Ketchum / SVWSD Water Reclamation Facility  
Aeration Upgrades

**ADDENDUM NO. 3**

February 21, 2024

PROCESS & INSTRUMENTATION DIAGRAM  
AERATION BASIN 03

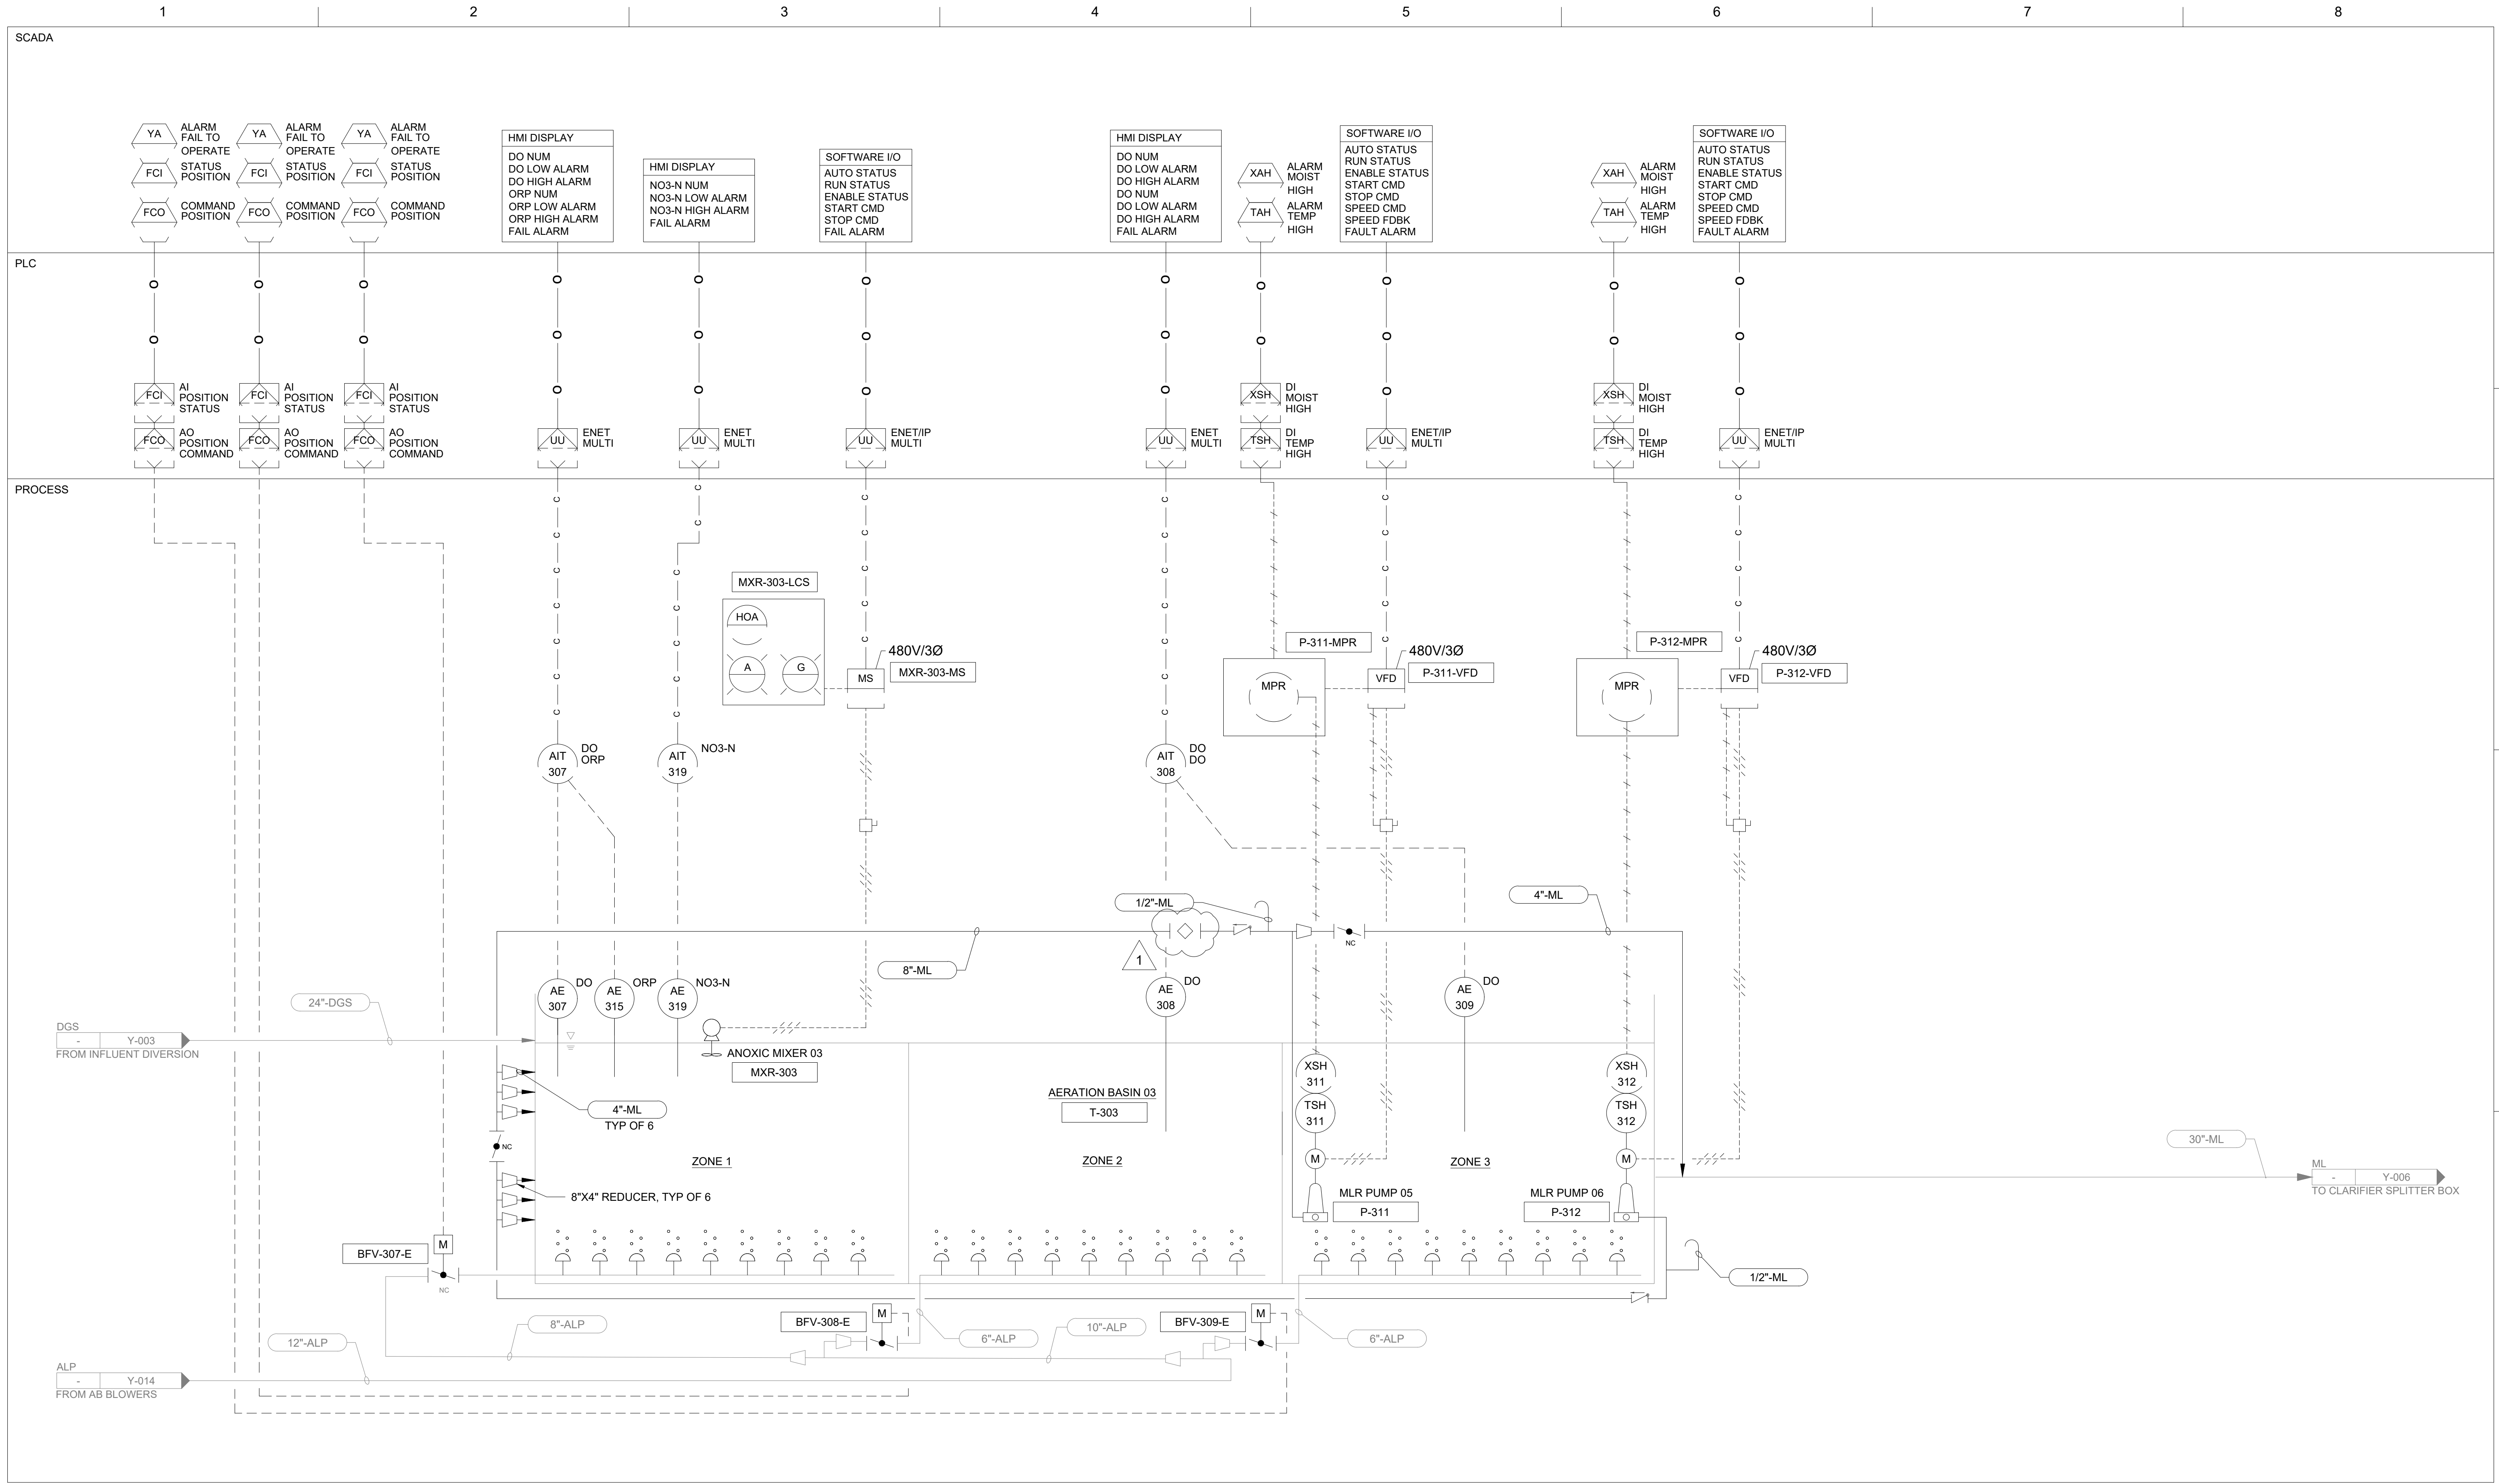
3.11 Drawing Y-001: Process & Instrumentation Diagram - Aeration Basin 03: Modify the Drawings as shown by Addendum No. 3 revision.

**PROCESS & INSTRUMENTATION DIAGRAM  
AERATION BASIN 04**

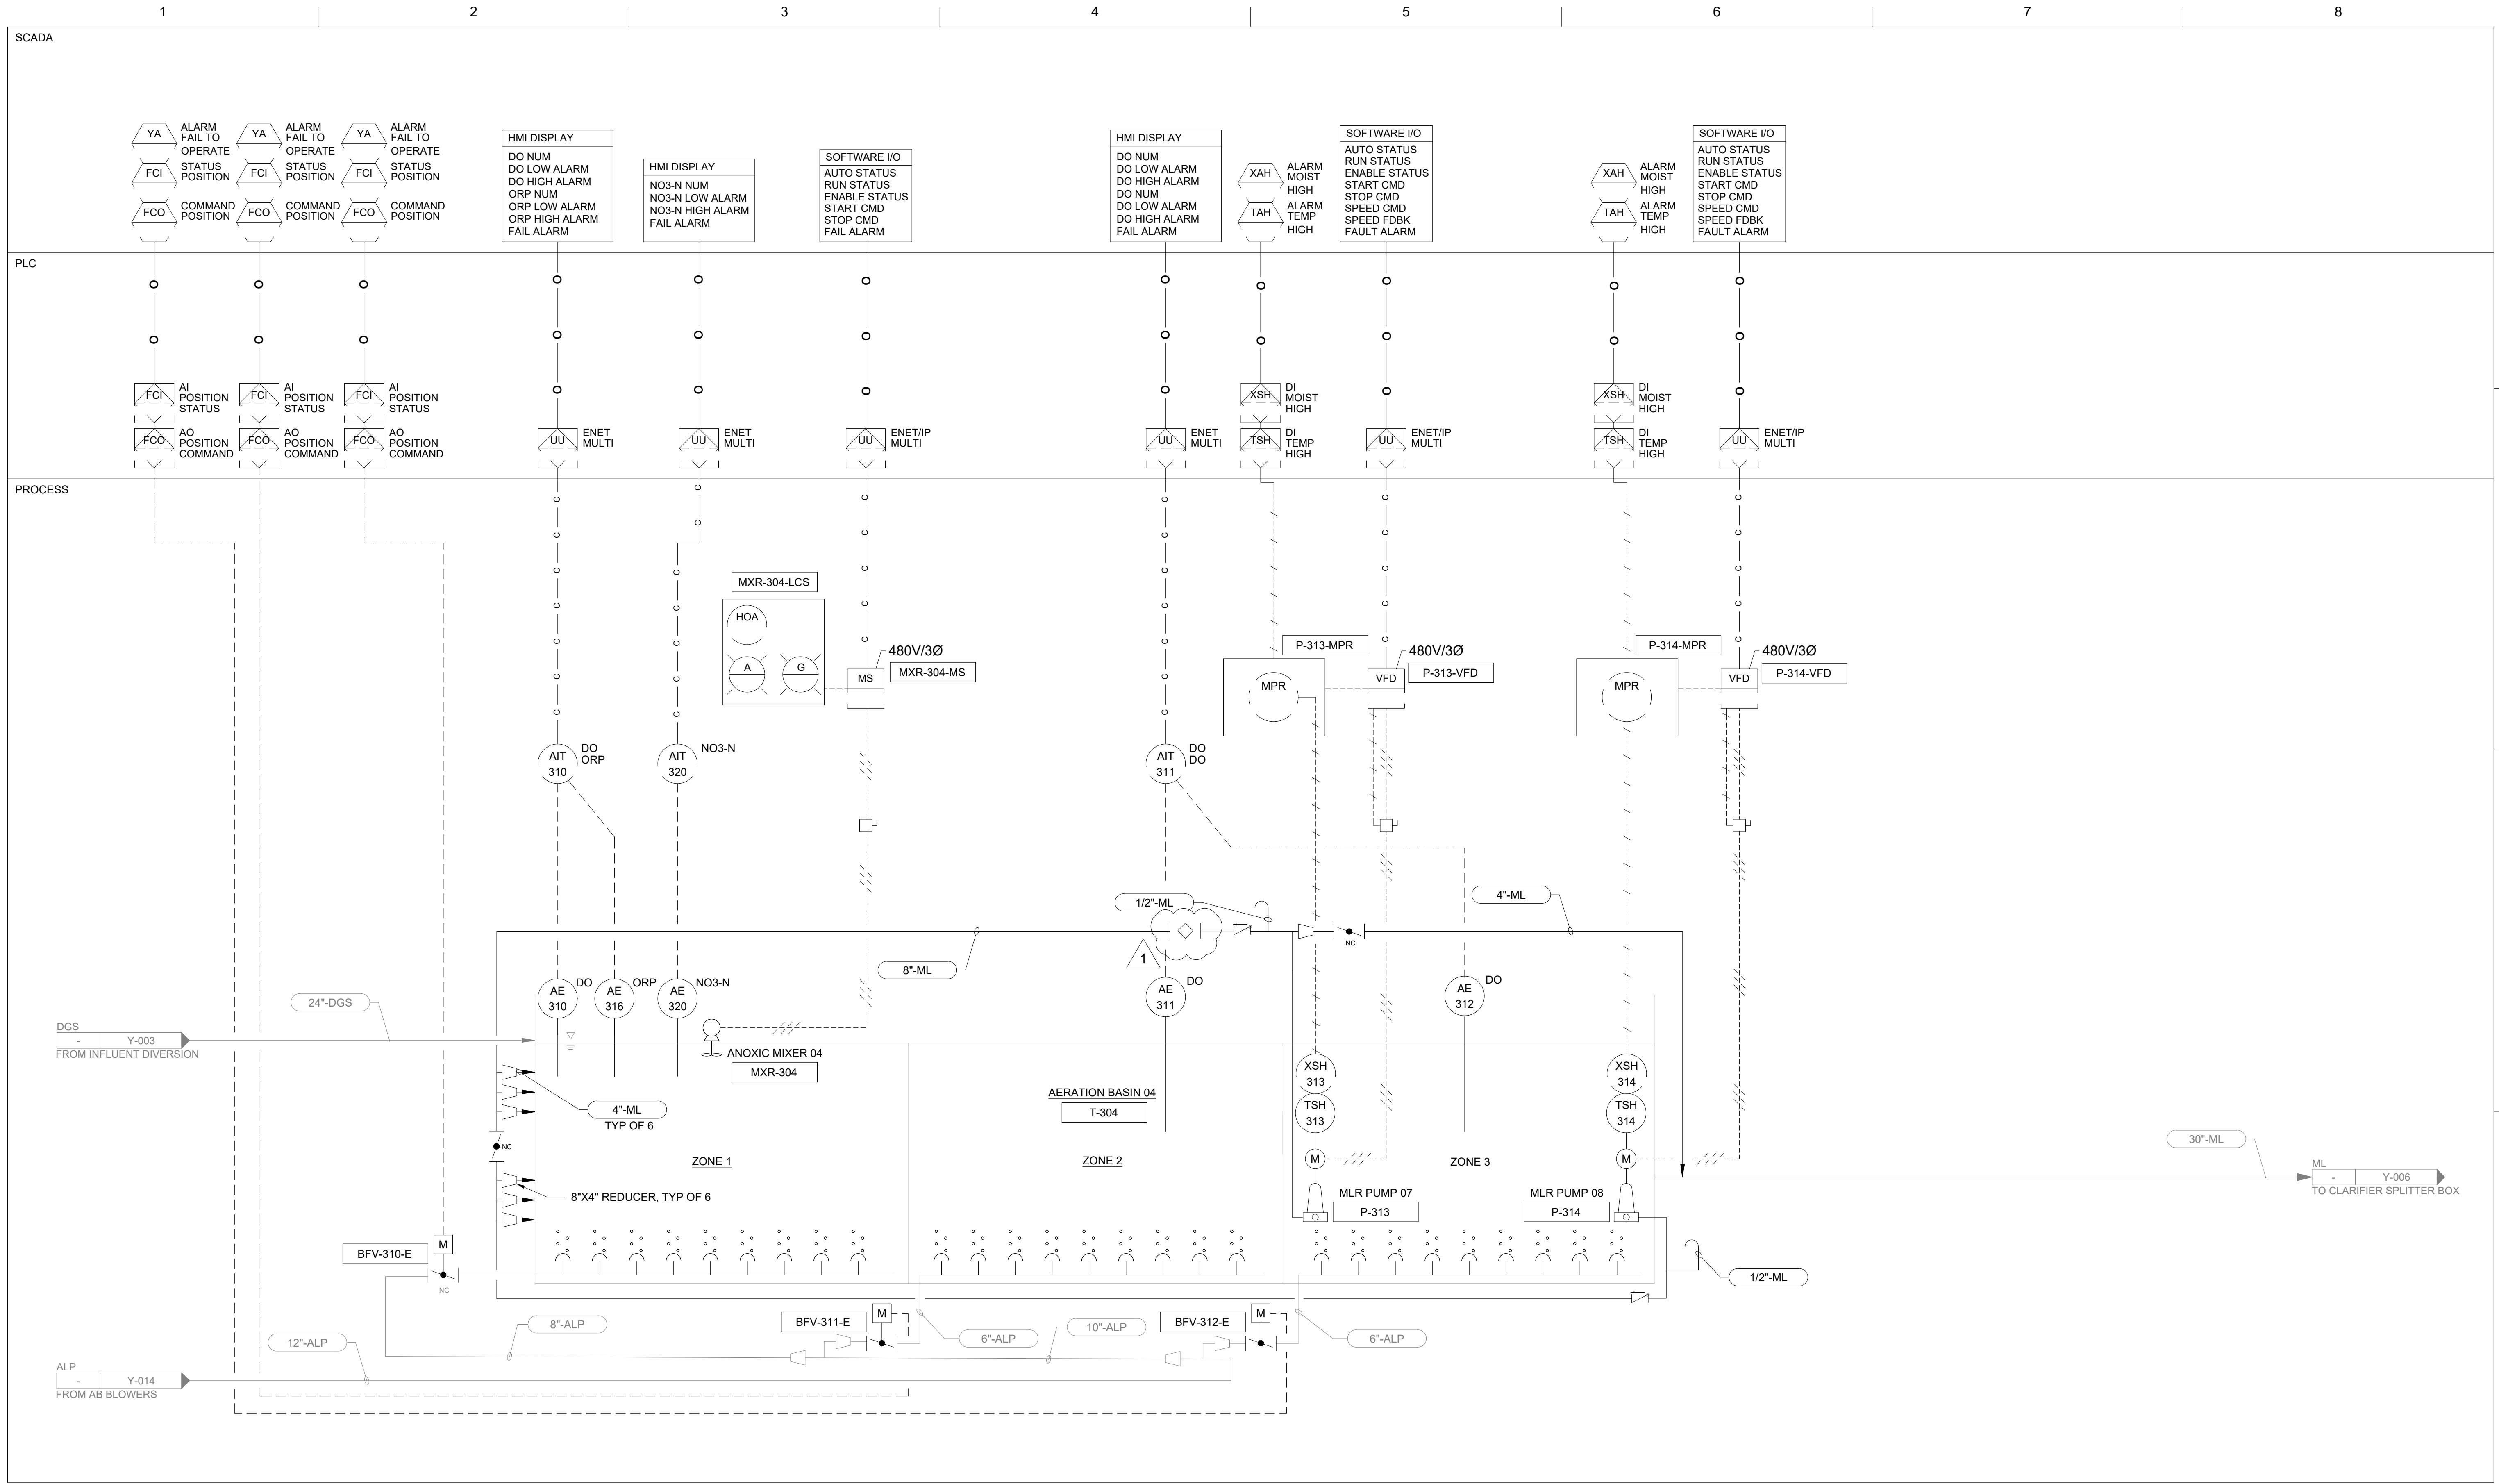
3.12 Drawing Y-002: Process & Instrumentation Diagram - Aeration Basin 04: Modify the Drawings as shown by Addendum No. 3 revision.

**PROCESS & INSTRUMENTATION DIAGRAM  
BLOWERS**

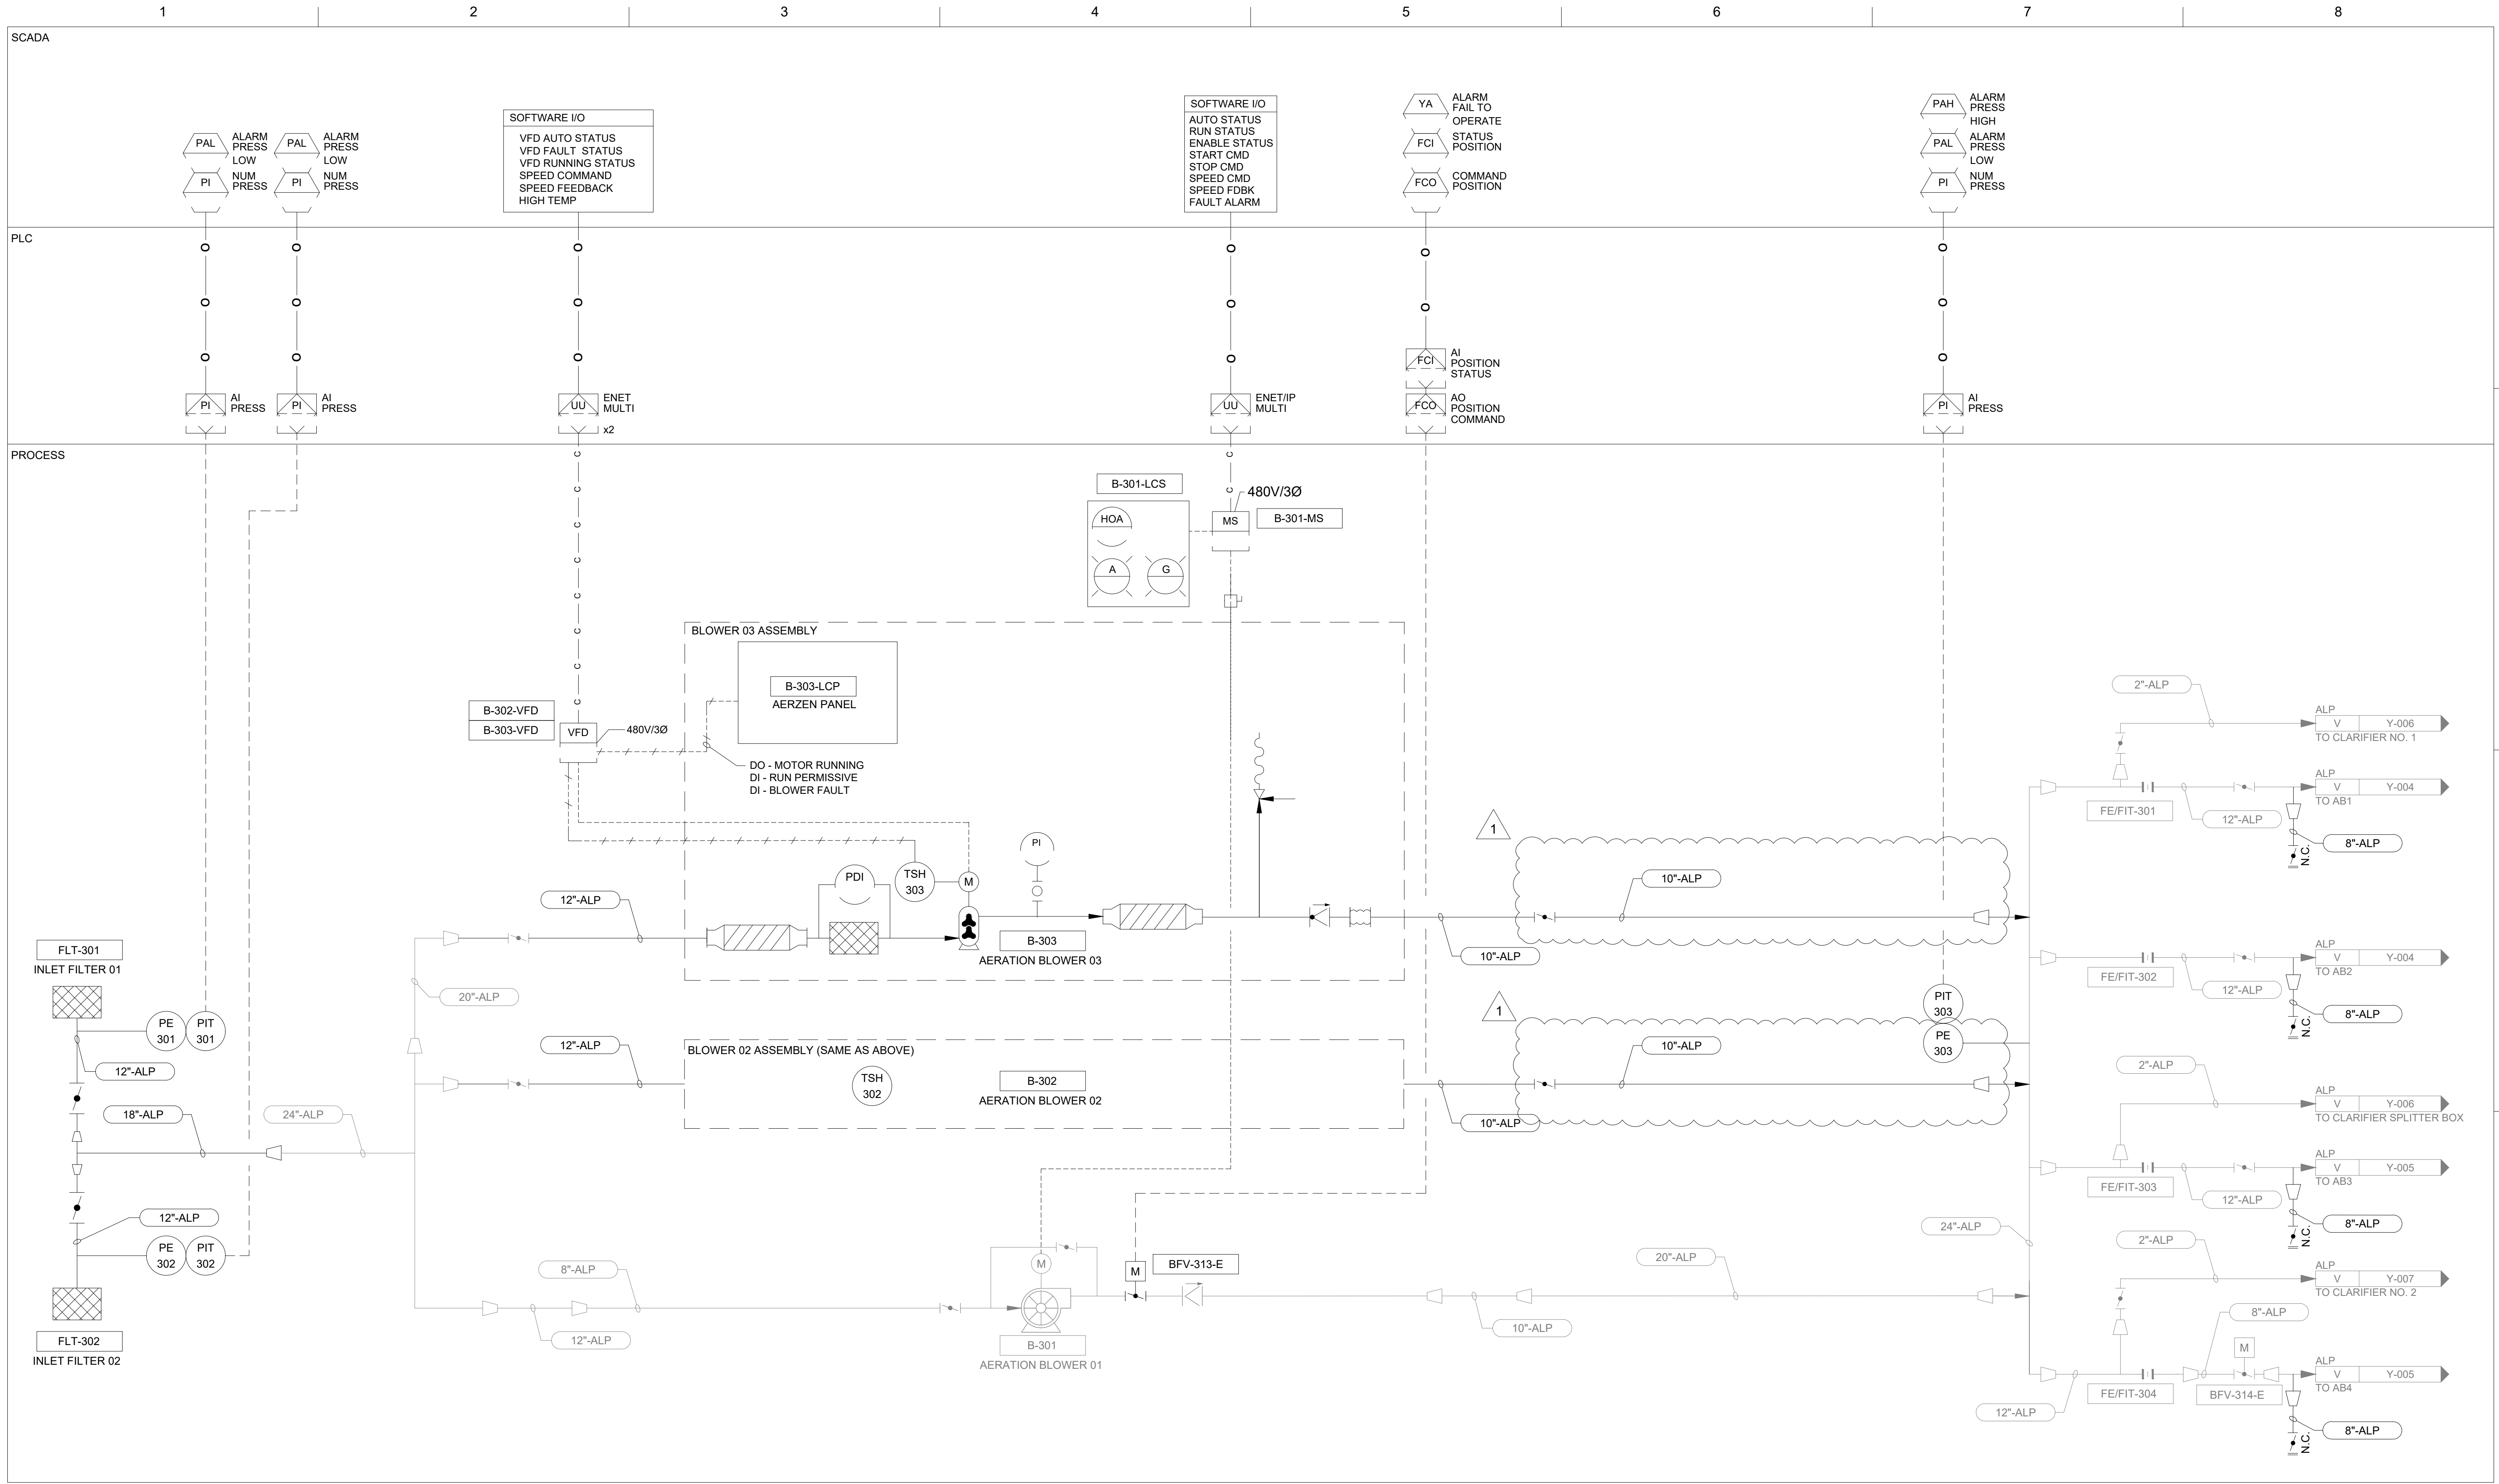
3.13 Drawing Y-003: Process & Instrumentation Diagram - Blowers: Modify the Drawings as shown by Addendum No. 3 revision.
